UNITED STATES PATENT AND TRADEMARK OFFICE

Office Action Summary	Application No. 10/534,364	Applicant(s) HISHIKAWA ET AL.	
	Examiner CHRISTOPHER D. KOHARSKI	Art Unit 3763

DETAILED ACTION

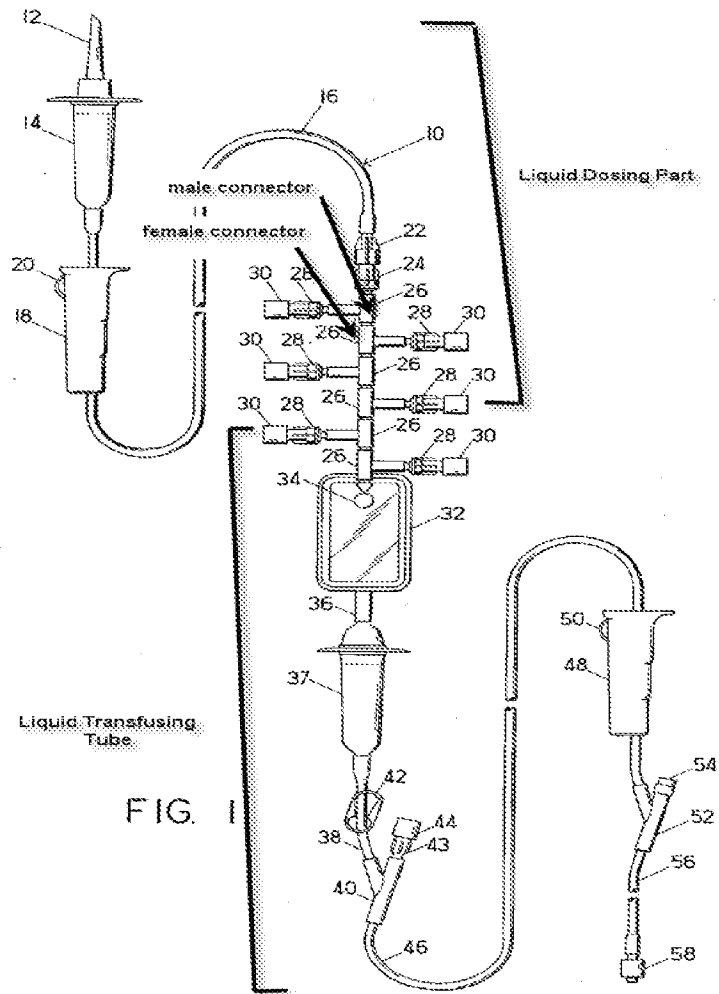
Regarding claims 1 and 5-11, Gula et al. discloses a liquid transfusing assembly (Figure 1) comprising: a tube constituting a liquid transfusing channel (fluid channel from element 16-26-46); a connector (26) provided at one end part of said tube and directly connected thereto; and a connection part (opposite side of element 26) provided on the other side of said tube and connected to the side of a containing part containing a transfusion (connected to spike 12); wherein said connector includes a male

connector and a female connector (tee spike distal/proximal ends (26)), and the axis of said male connector and the axis of said female connector substantially coincide with each other (along longitudinal axis of center of tee spikes 26); and a liquid dosing part (assembly from 12-upper tee connector 26) for dosing a patient with said transfusion, said liquid dosing part having a liquid dosing part side connector (upper tee 26) capable of being connected to one of said male connector and said female connector of said connector of said liquid transfusing tube (46-26); wherein in the condition where one of said male connector and said female connector of said connector of said liquid transfusing tube and said liquid dosing part side connector of said liquid dosing part are connected with each other, the other of said male connector and said female connector of said connector of said liquid transfusing tube can be connected to a liquid transfusing tube other than said liquid transfusing tube (Figure 1, see marked up figure below).

Gula et al. further discloses the liquid dosing part having a bacteria-removing filter (32, col 3, ln 55-65) provided on the downstream side relative to said liquid dosing part side connector; wherein said liquid dosing part has a mixing injection port (43) on the downstream side (defined as fluid flow from 12 to 58) of said bacteria-removing filter (32); and wherein said liquid dosing part side connector is branched into a plurality of parts (tees 26) so that a connector provided on the other end side of a tube having on its one end side a connection part connected to another liquid container (tee ends 28) other than said liquid container and said connector of said liquid transfusing tube can be simultaneously connected (Figure 1, col 3, ln 30-55, see marked up figure below).
